**JURUPA COMMUNITY SERVICES DISTRICT
RIVERSIDE, CALIFORNIA**

ADDENDUM NO. 4

**TO THE PLANS AND SPECIFICATIONS FOR
RECYCLED WATER PROGRAM – SEGMENT 3 FINAL DESIGN
JCSD P.N. C215078**

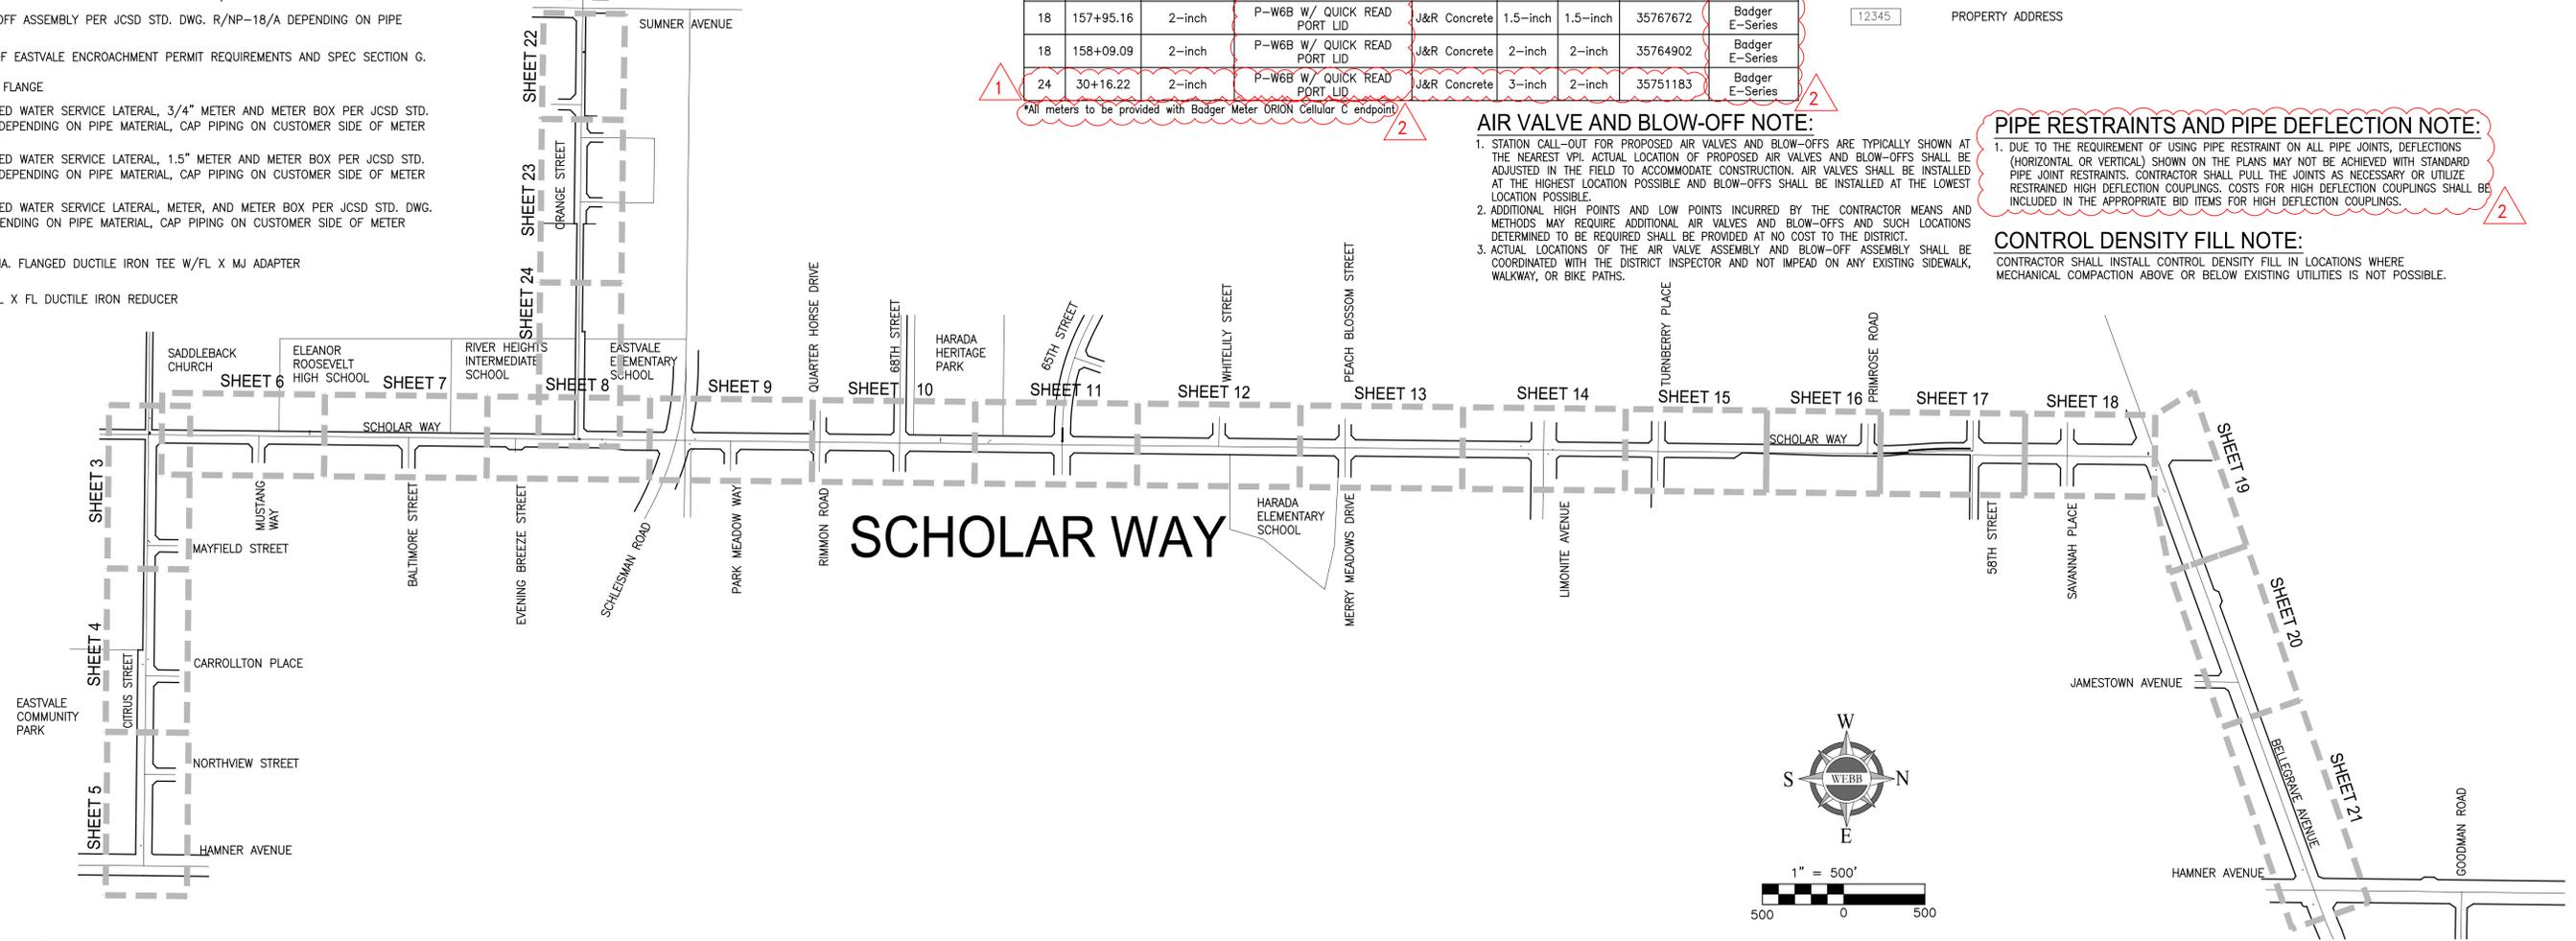
Sheet 2 has been revised to include Construction Note No. 37 describing the Installation of 18-inch diameter flanged ductile iron cross with FLxMJ adapters that is to be installed at the intersection of Scholar Way and 65th Street, as well as Construction Note No. 38 which describes an 8-inch flanged tee to be installed to accommodate connection to the future Tract No. 38167 recycled water connection.

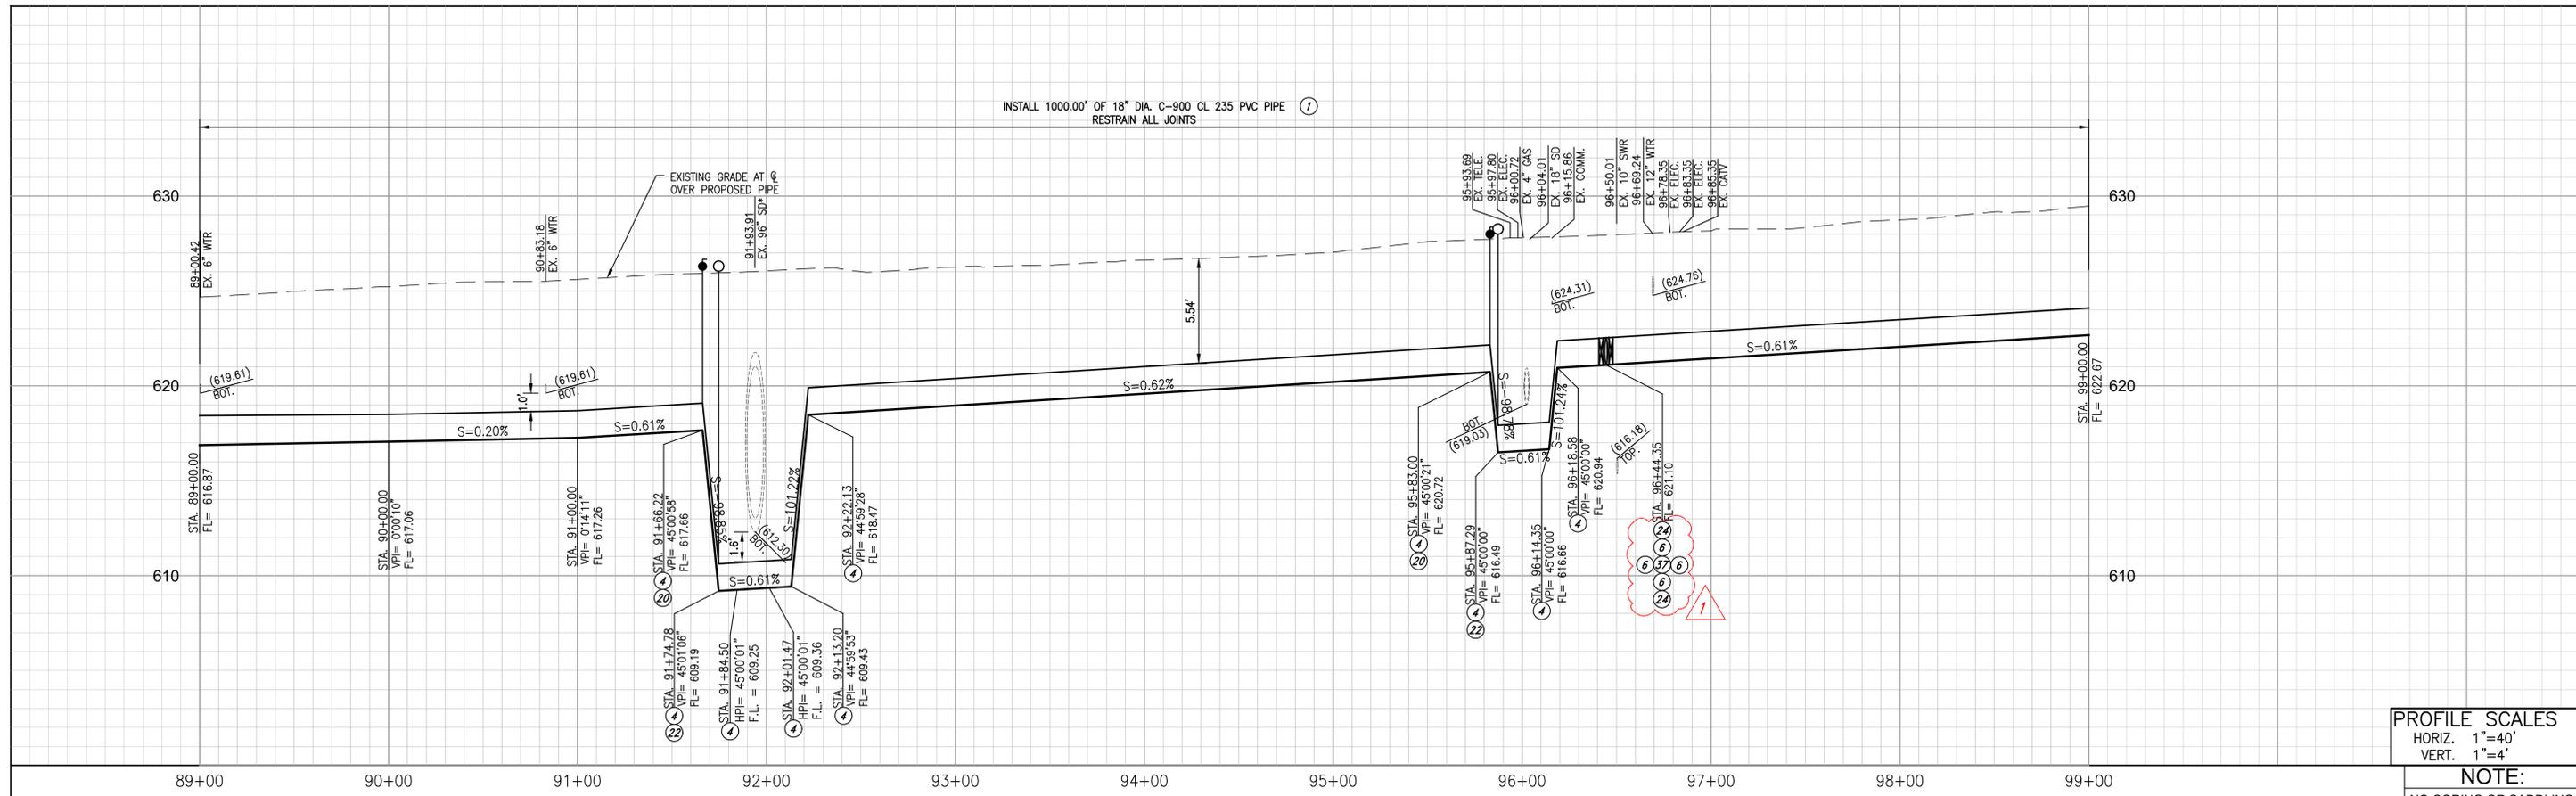
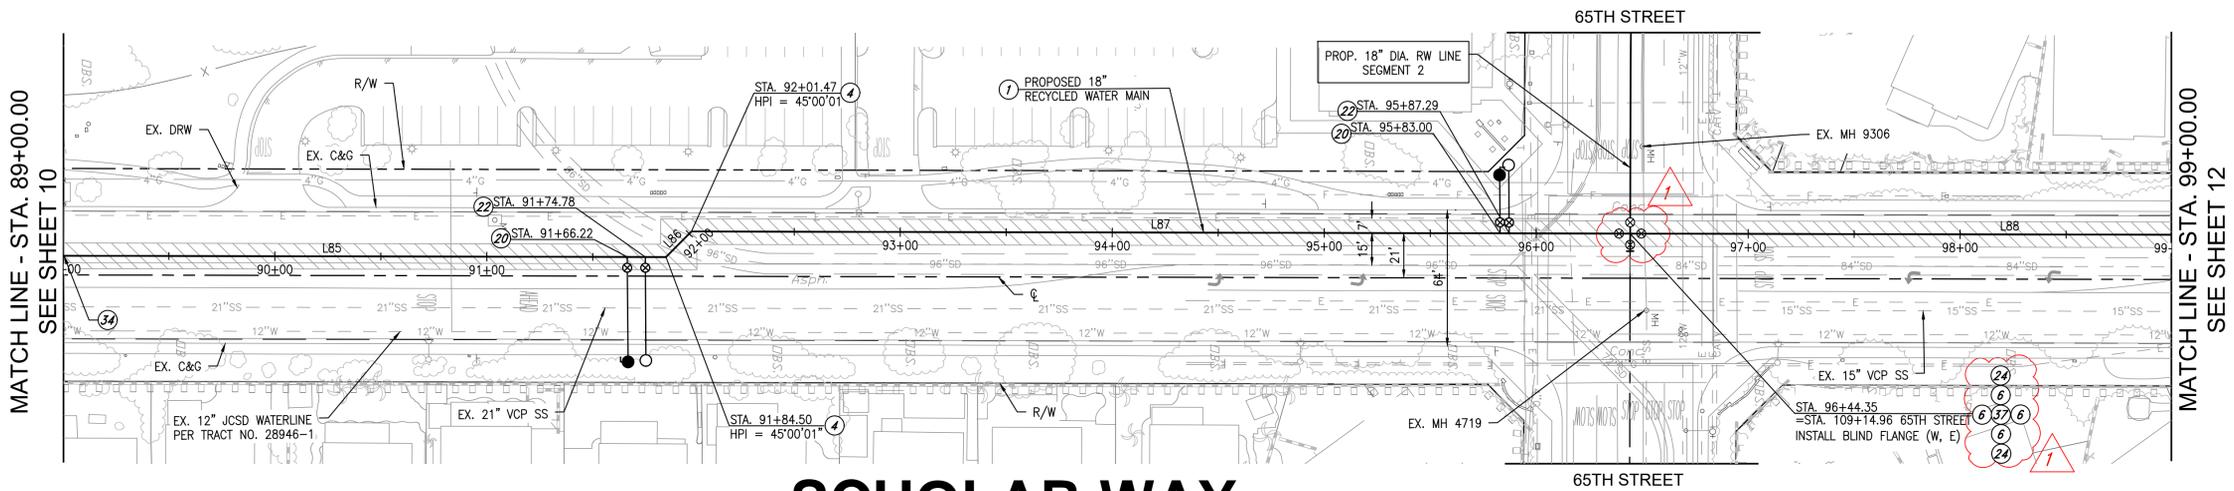
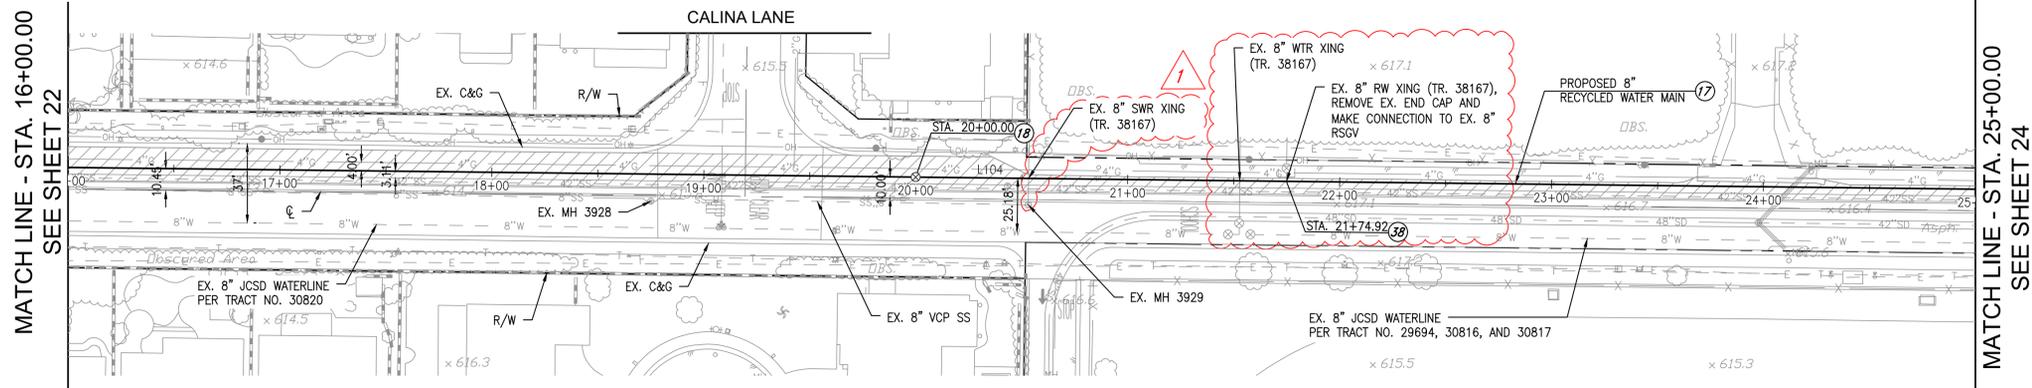
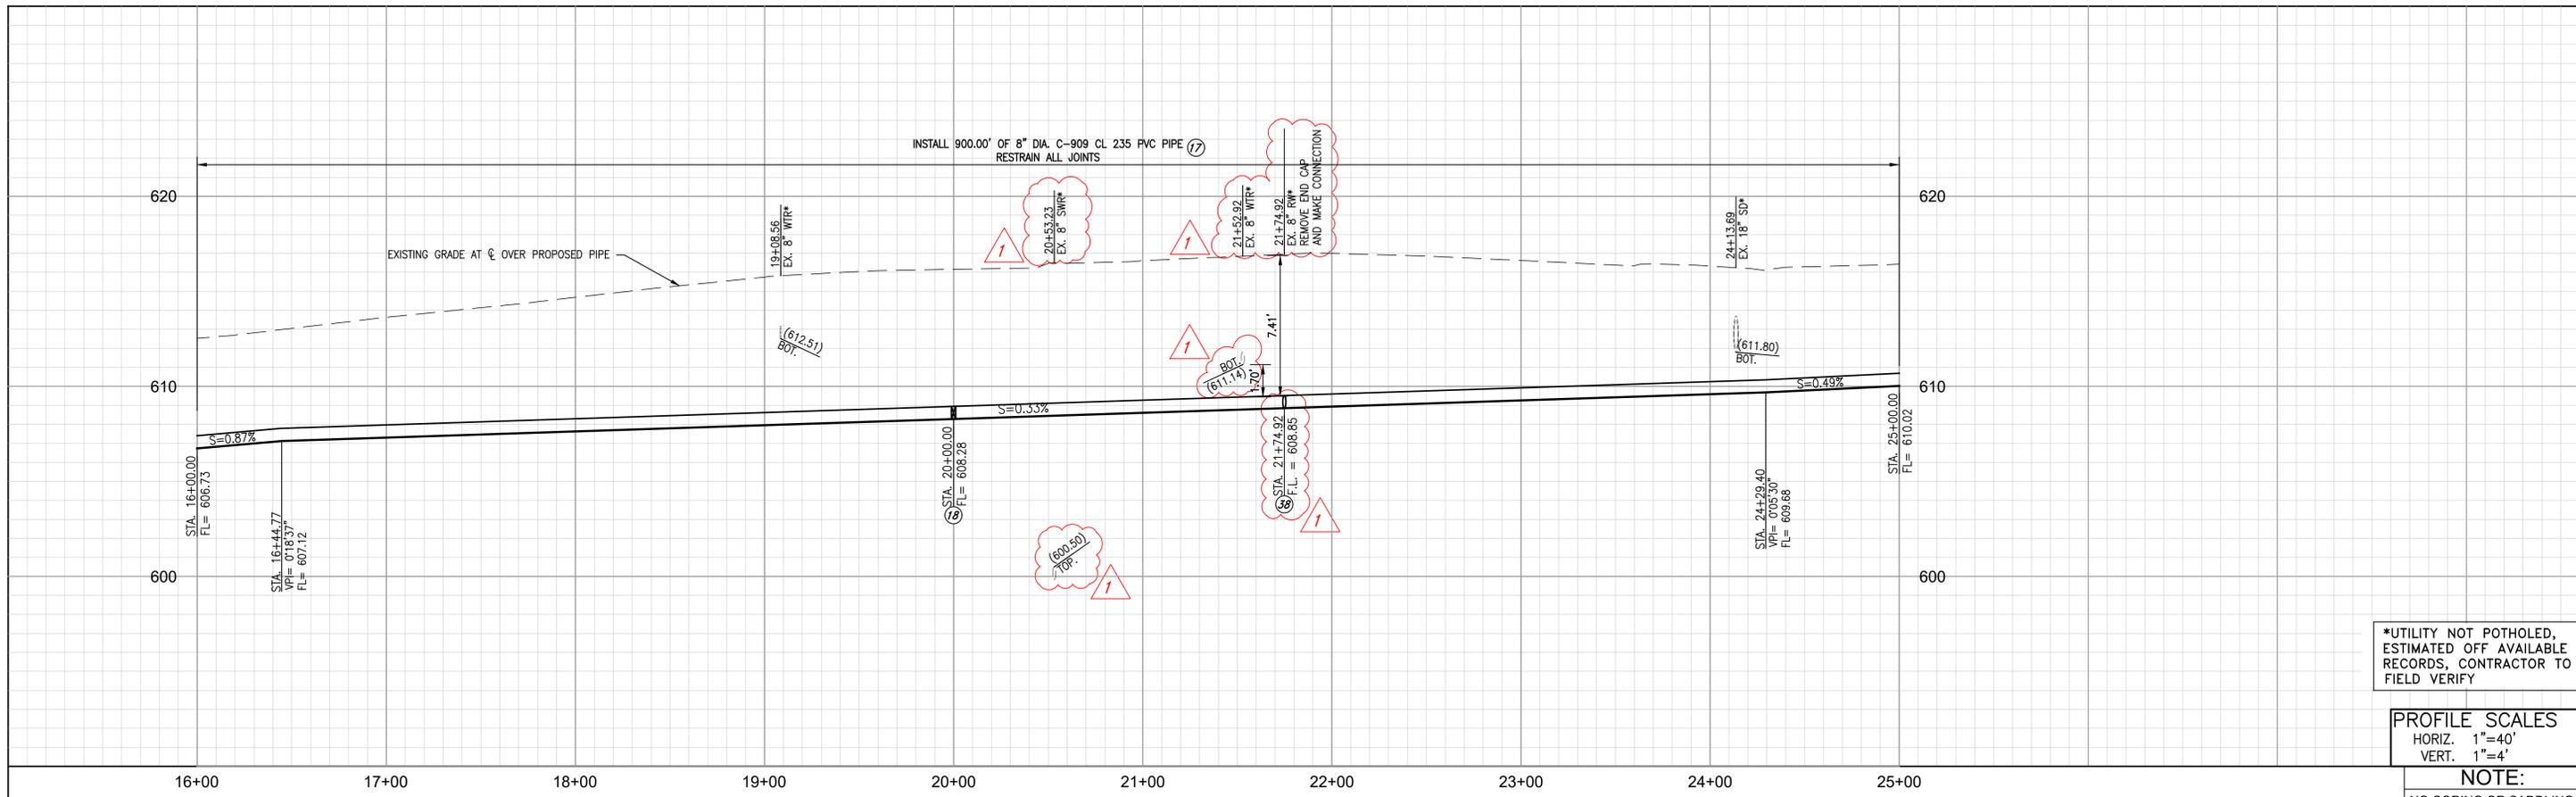
Sheet 23 has been revised to include a future development project with potable water, recycled water, and sewer lines that will be constructed prior to the construction of Segment 3 Recycled Water on Orange Street. The future Tract No. 38167 development will construct an 8-inch gravity sewer that will connect to the existing manhole ID No. 3929 on Orange Street, as well as 8-inch diameter recycled waterline that will be blind flanged until connection is made during the Segment 3 construction. The 8-inch gravity sewer, 8-inch recycled water, and 8-inch potable water (by others) has been added to the plan and profile as an existing

utility crossing or connection. An 8-inch flanged tee has been added to the plan and profile at the proposed connection point.
